ITEM: Public hearing on a request for a rezoning from R-1 to Planned Unit Development (PUD) and approval of a preliminary plan for the Questwood Townhome Development at 1859 North Snelling Drive

PLANNING REPORT

RE: QUESTWOOD SITE PLAN REVIEW

PRELIMINARY PLAT
of
QUESTWOOD

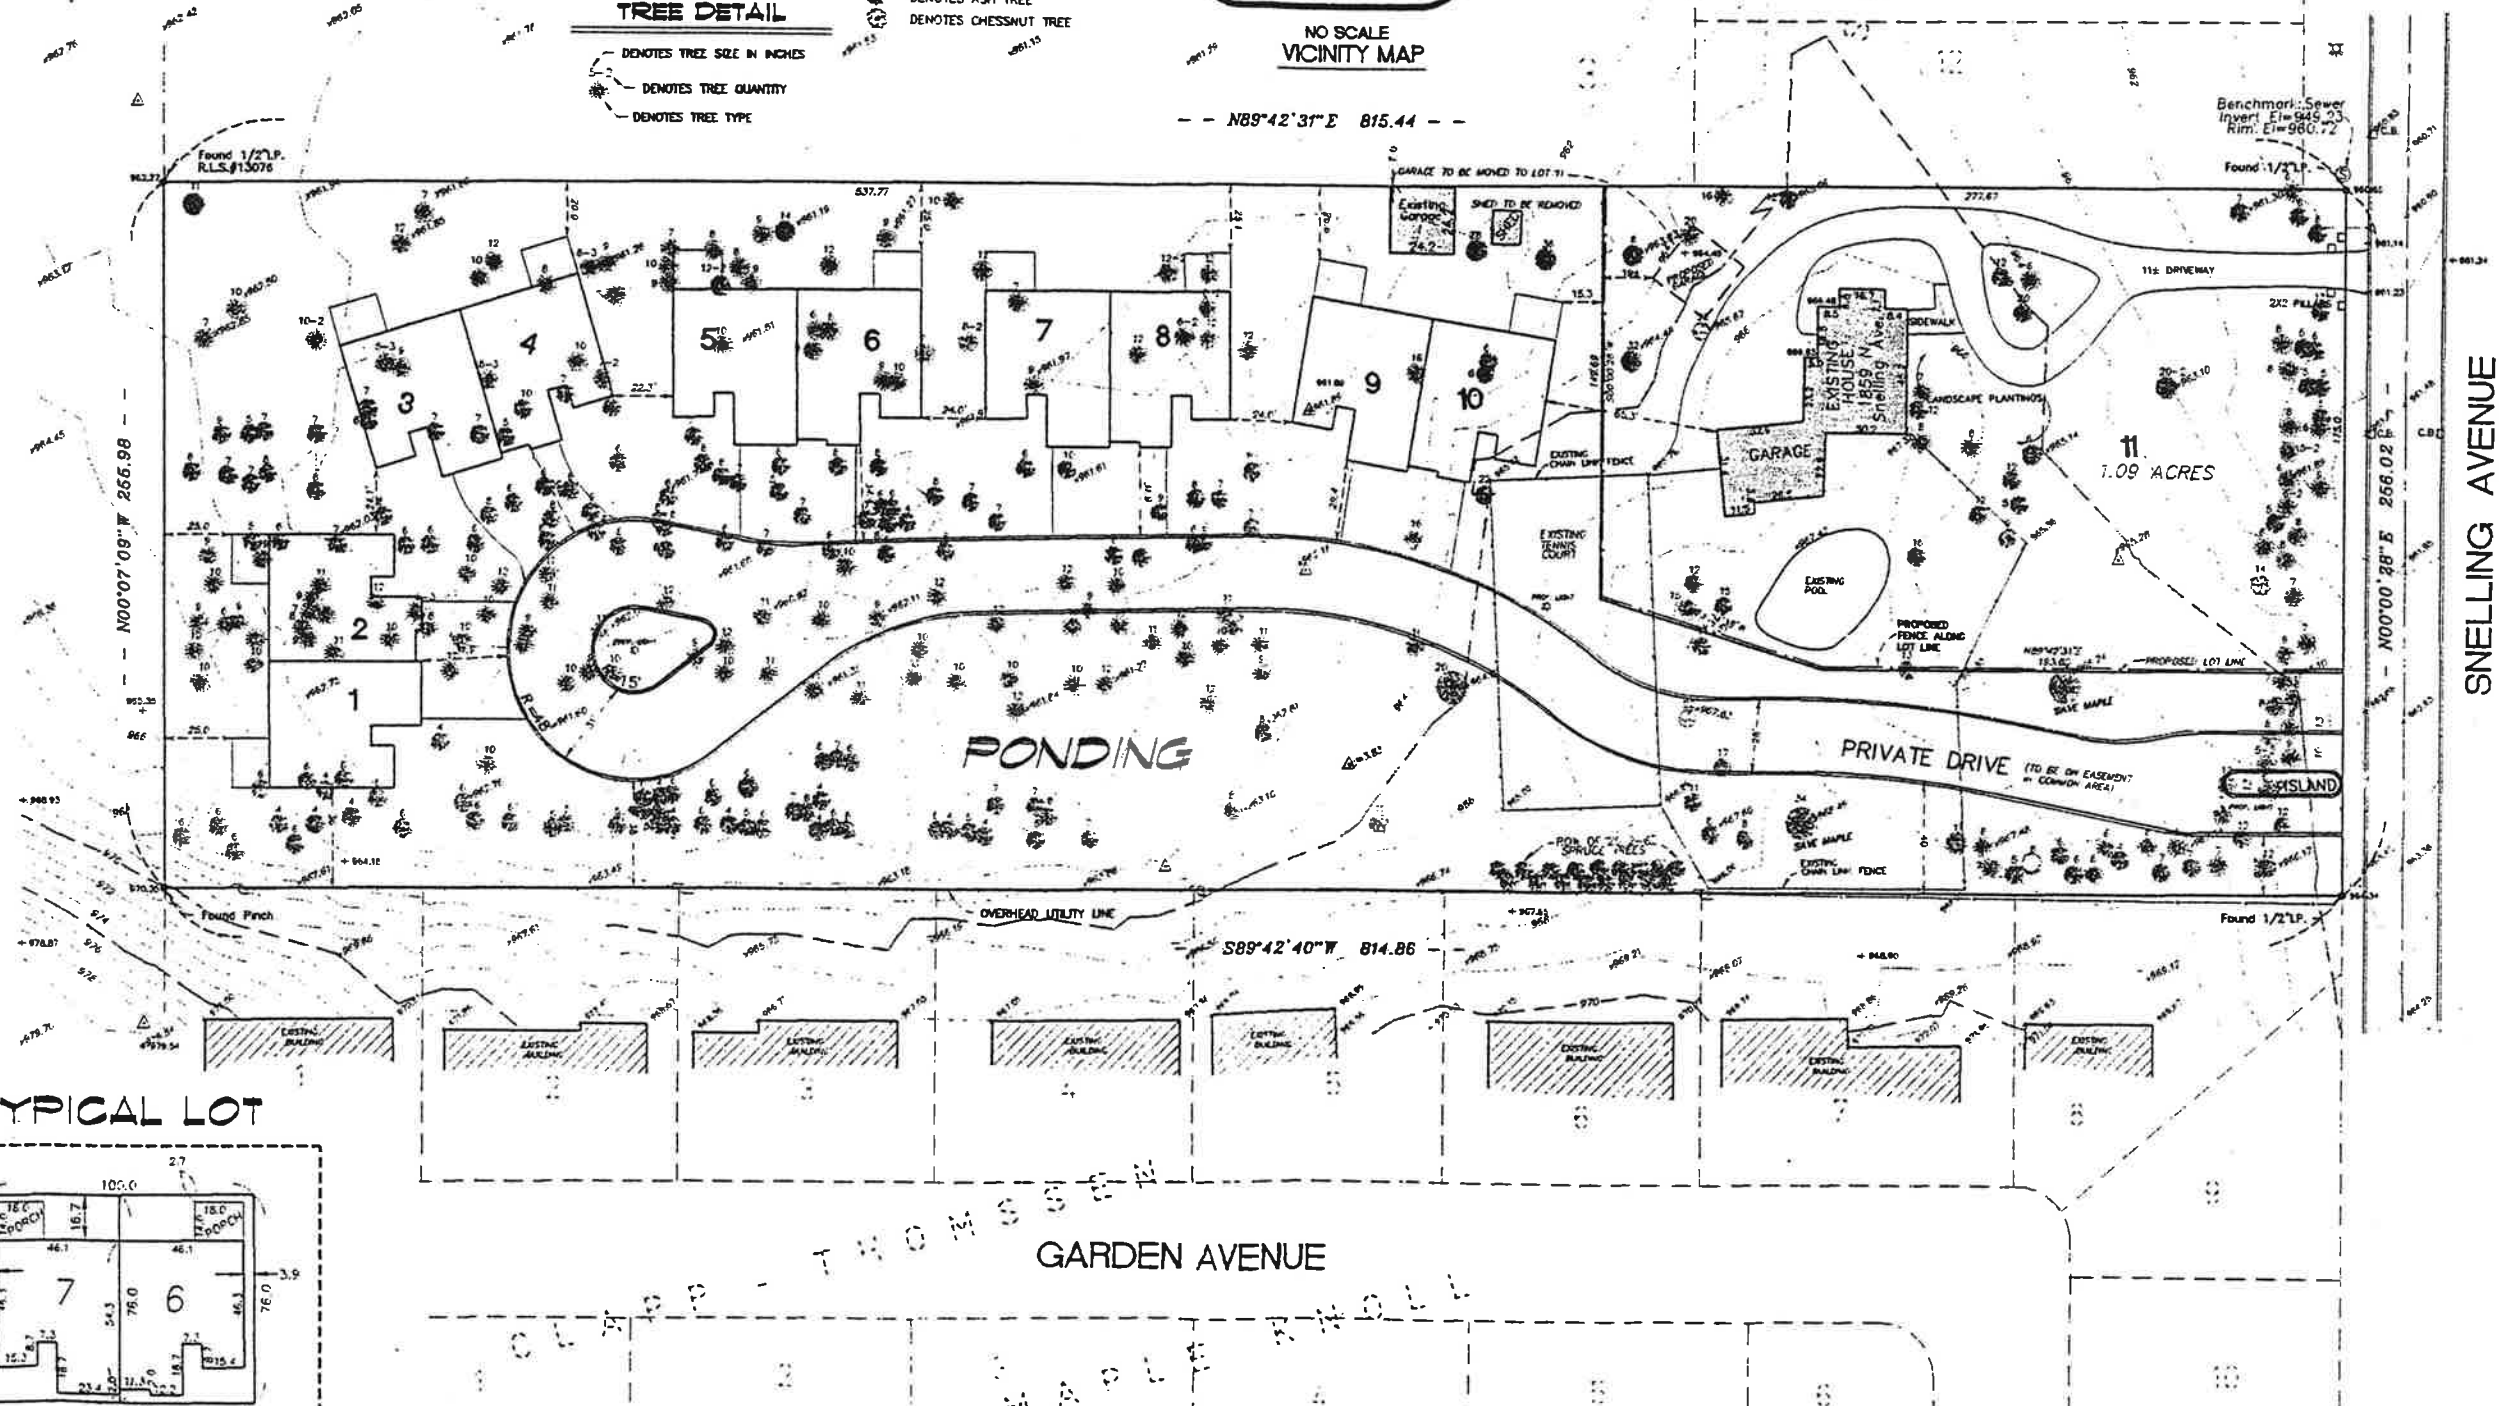
- 2) Proposed density, including the single family home, is 2.29 units per acre. The buildings meet all applicable front and side setbacks and height requirements. However, due to the covered porches in the back of the units, most of the structures do not meet the rear setback requirement. The main structure meets the setback, it is only the covered porches that encroach upon the rear setback requirement of 30 feet. Six of the ten porches are setback 25 feet, one is setback 26 feet, one is setback 20 feet, and two are setback 40 feet.

8) Access to the site is via a private road connecting to the Snelling Avenue Frontage Road. The private road will have a 9-ton load capacity, which would allow trucks of any size to use the road year-round. The street will meet City design criteria and will have curbs and gutters. A Townhome Association will be responsible for upkeep and maintenance of the proposed road. The road is proposed to be 28 feet in width and 706 feet long. The street width is consistent with City standards and consistent with other metro area City's street width requirements, which typically range from 26 to 32 feet. The turn around radius of the cul-de-sac also meets City standards. The City requires a maximum cul-de-sac length of 400 feet. Cities typically require a maximum length of a cul-de-sac to assist in fire fighting with the thought being the longer the end of a street is from its access street, the more difficult it is to get fire fighting equipment to a fire. It should be noted, however, that many Cities have 600 feet as their cul-de-sac maximum length and there is little, if any, evidence that a long cul-de-sac has inhibited a Fire Department's ability to fight a fire. In order to assist with fire protection, a fire hydrant will be located at the end of the cul-de-sac. In addition, all the homes are located on one side of the street which would also assist in the Fire Department's ability to fight a potential fire at the site.

11) Sanitary sewer and water utilities will be provided via an extension from the Snelling Avenue Frontage Road. A storm water detention pond is planned for the area south of the proposed road. Utilities will be built to City standards and will be properly sized. Water will be provided by St. Paul Water Works. All other utilities, including electricity, gas, phone, and cable will be provided to the site. Street lights will consist of those similar to the old street lights still found in some St. Paul neighborhoods. The Engineer's report will outline any concerns with storm water drainage.

13) The developer is proposing to transplant many of the removed trees to appropriate locations on the site, including 46 Spruce, 32 Tamarack, 2 Ash, and 5 Pine. The buildings will be landscaped in accordance with developer's plans. Most transplanted coniferous trees are to be located along the north and south property line to buffer adjacent uses. An irrigation system will be in place around the buildings and in the common areas. The Developer's Agreement will outline in detail the landscaping and will include a letter of credit that can be used by the City if the applicant fails to complete the landscaping or entrance island as outlined. There is no entry monument indicated on the submitted plans.

1. It appears from the Grading Plan that at the most severe point, the proposed road to serve the site will be raised from the existing grade approximately three feet. The proposed road will come off of Snelling Drive at approximately 963, rise to a high point of 966, and then back down to a low point of 964.7, before rising to a high point at the west end of 966.5. The first floors of the proposed buildings will be 967 for the three easterly buildings, and the two westerly buildings will be 967.5. As a reference point, the lowest existing house to the south appears to have a walkout elevation of approximately 967. In other words, the first floor of the proposed townhomes will be the same elevation as the basements of the homes to the south.

3. The Developer has provided a Drainage Plan that shows that in a 100-year storm event, the peak discharge from the site will be maintained at a level equal to the peak discharge from the existing site in the same 100-year storm. In other words, peak discharge after development will be equal to or less than pre-development peak discharge. This will be accomplished by constructing a small detention pond south of the proposed road. In a 100-year storm, the peak discharge from this retention pond is 2.4 cubic feet per second (cfs). To minimize the impact of even this minor concentrated flow to the University property to the north, the proposed discharge system consists of 200 feet of 8-inch draitile. We believe that this approach will do an adequate job of minimizing if not eliminating any adverse affects to the University fields to the north from the development of this property.

1. The existing sanitary sewer and water facilities to service this site are located at the northeast corner along Snelling Drive. Sanitary sewer is proposed to be brought through the single family lot with a manhole placed in the driveway and the next manhole south in the proposed street. Then the sanitary sewer is proposed to be extended westerly along the proposed street. Sanitary sewer is proposed to be 8-inch diameter plastic pipe. Each townhome unit will have an individual 4-inch service.

2. Watermain service is provided along the same alignment by 6-inch ductile iron pipe. There are two hydrants proposed, one at the east end of the townhome units and one at the west end of the cul-de-sac. These two hydrant locations will provide adequate fire protection. Since the City of Falcon Heights just recently turned over its water system to the St. Paul Water Utility, it will be important that the Developer designs and builds the proposed water improvements to the criteria provided by the St. Paul Water Utility.

- The memo asked for the private road to be a minimum of 7-ton design to support fire equipment. I indicated that the City PUD ordinance requires that the road be up to City standards. We have provided that information to the Developer and believe that the road construction will meet or exceed the 7-ton weight requirement requested.

- The memo requested that a fire lane be provided along the north side of the property or, in lieu of providing this fire lane, that the buildings all be sprinklered. When we met, I indicated that I had not had any experience with developments such as this being required to place a fire lane in the design. I also indicated that it was my understanding that sprinklering of buildings was dictated by fire code and not necessarily by the City. Given the size of these buildings, which are not much larger than today's largest single family homes although they are larger than most single family structures in the City of Falcon Heights, I did not feel it was appropriate to support the recommendation that a fire lane be provided along the north side of the site. I felt that the fire lane would be contrary to many of the other things trying to be accomplished by this development, such as moving the townhome units as far away from the existing single family homes to the south and also tree preservation wherever possible.

- The memo asked for a 20-foot access for fire department use along the proposed street. We discussed this and indicated that the proposed street is 28 feet in width. Given the driveways, hydrants, and mailboxes to be located along the north side, it is unlikely that there will be much, if any, on-street parking on the north. Given the size of the units with 2-car garages and large

2) The single family residential unit will have to be included as part of the platted PUD. The City requires 200 feet of public street frontage and only by including the single family home can that frontage requirement be met. As part of the PUD agreement, the developer can differentiate between the townhome development and the single family home, allowing the single family home to be owned and maintained separately from the townhome development. Also the Single Family home can not be developed as townhomes or any other use without an amendment to the PUD.

3) Due to the fact that the porches on the units will be covered, they are considered part of the principal structure and will be in need of a variance. The PUD ordinance states that setbacks on the perimeter of the site shall comply with the setbacks of the underlying district. The rear setback requirement in the R-1 District is 30 feet. The porch setbacks, as shown on the plan, range from 18 to 46 feet with the majority of them setback about 25 feet. A variance is justified if there is an undue hardship or practical difficulty in meeting the terms of the Code. In this case, the storm drainage pond located on the project's southern side prohibits the road and the units from moving to the south to meet the setback requirements. It should also be pointed out that the structures in question abut University of Minnesota agricultural fields and not other residential structures. Further, the main structures meet the setback requirement and it is the covered porches that cause the need for a variance.

4) The length of the private road is in need of a variance due to the fact that it extends beyond the City requirement of a maximum of 400 feet for a dead-end road. A variance is justified if there is an undue hardship or practical difficulty in meeting the terms of the Code. In this case, the site is bounded by University of Minnesota farm land which has been declared "sacred" and will never develop. In order to properly access the entire site, the longer street length is required. The alternative is to build a street 400 feet and then provide access to the remaining units via a private driveway. This alternative is considerably less desirable than a longer street and it could be argued offers even more difficulties for fire protection access than a longer street would provide. The private road can not be converted to a public road in the future and must be maintained by the Townhome Association.

5) The private road shall be platted with an easement allowing the community to use the road and road right-of-way for any reasonable public purpose including but not limited to travel by emergency vehicles and the installation of public utilities.

7) No new structures or new paving will be allowed other than those outlined in the Preliminary Plan.
